Initial Project Review

Variance / Site Plan Review: Nguyen (Driveway Retaining Walls)

Application Numbers: 903764, 903765

Proposal: Request to vary from zoning setback and design standards for height of wall. Site Plan Review to vary from design criteria for height of retaining walls.

Cross Section

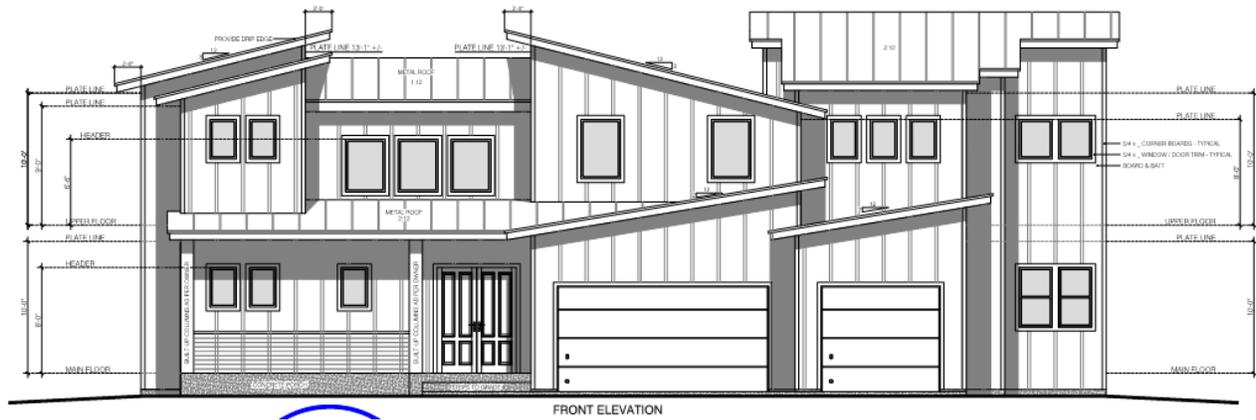
Staff Comment: This proposal consists of retaining walls designed to stabilize a steep slope and driveway approach. The driveway approach follows the natural topography as much as possible and retaining walls may be necessary to stabilize the slope. Currently, a Site Plan Review to deviate from a countywide design standard is being reviewed due to the 12-foot height. It appears at this time that a tree conservation plan will be required due to significant trees existing on site.

Staff Comment: The proposal seeks to establish a retaining wall that encroaches into the side setbacks, within 3 feet of the South property line. Staff recognizes that the property is very steep and possibly in need of some form of slope retention. The granting of the retaining walls and associated driveway would result in the removal of a substantial number of trees and vegetation within shoreline jurisdiction. This removal of vegetation is inconsistent with the Gig Harbor Community Plan and the Comprehensive Plan and would result in a significant loss of vegetation affecting the nearshore environment.

Without a tree conservation plan for this site staff would have to recommend denial based on significant adverse environmental impacts as a result of the granting of this variance. The removal of significant trees would damage the ecological function of the near shore environment and the required regrading and retaining walls could further effect erosion of the slopes around the site.

Note: This request fails to meet criteria 3, 4 and 5 of the Variance criteria in 18A primarily attributed to the lack of a tree conservation plan. The deviation from side setbacks exceeds the 20 percent threshold and thus requires LUAC and Hearing Examiner review. Impervious surface coverage within the 200-foot shoreline jurisdiction is approximately 24 percent.
